MEMORANDUM

RE: 170 and 180 Carrigan Drive, ZP14-1000CA

Request: Undergraduate student housing and dining facilities

Recommendation: Certificate of Appropriateness **approval**, per the following findings and conditions:

2. *Lot Coverage*

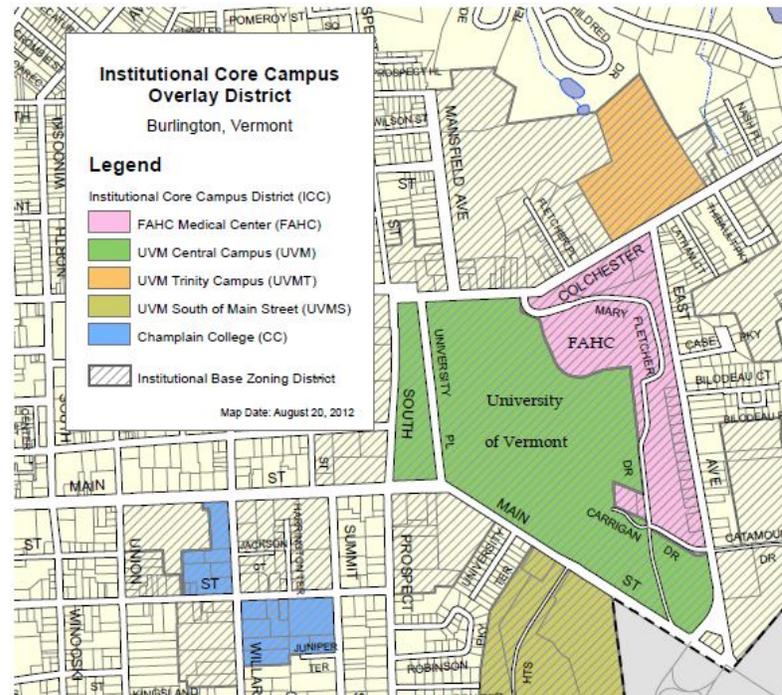
The CBW demolition and subsequent parking lot redevelopment projects defined lot coverage post construction as 47.56%. An email received May 27, 2015 from the applicant revised that calculation to 49.57%. From this information, the development falls beneath the 65% maximum.

4. Surface Parking

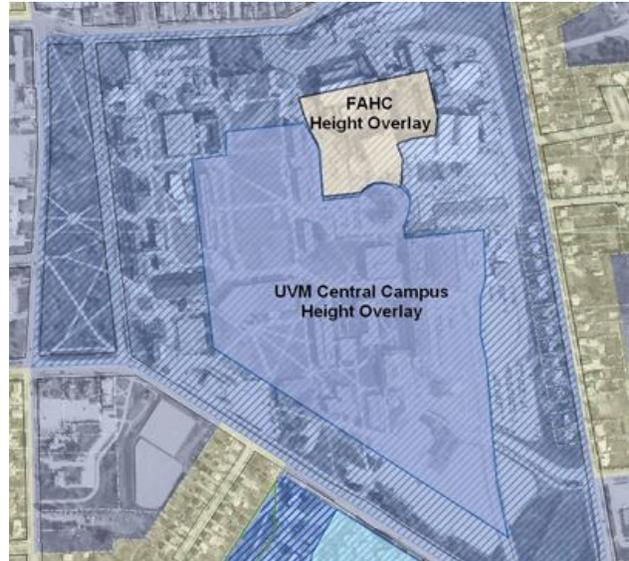
Nine new surface parking spaces are illustrated on the provided site plan, along the easterly curved access. The applicant will be required to identify the removal of a similar number of surface parking spaces to acknowledge these new spaces, or remove these surface parking spaces from the plan. **Affirmative finding if conditioned.**

1. Per Section 4.5.2 (d) 4, **no new surface parking spaces may be approved** by the DRB without the corresponding removal of outdoor surface parking spaces existing prior to January 1, 2007. The applicant will be required to demonstrate removal of existing spaces if the nine new surface parking spaces east of the proposed dormitories are to be included in the plan; otherwise the nine new surface parking spaces shall be removed from the plan. A revised site plan reflecting that change will be required **prior to release of the zoning permit.**
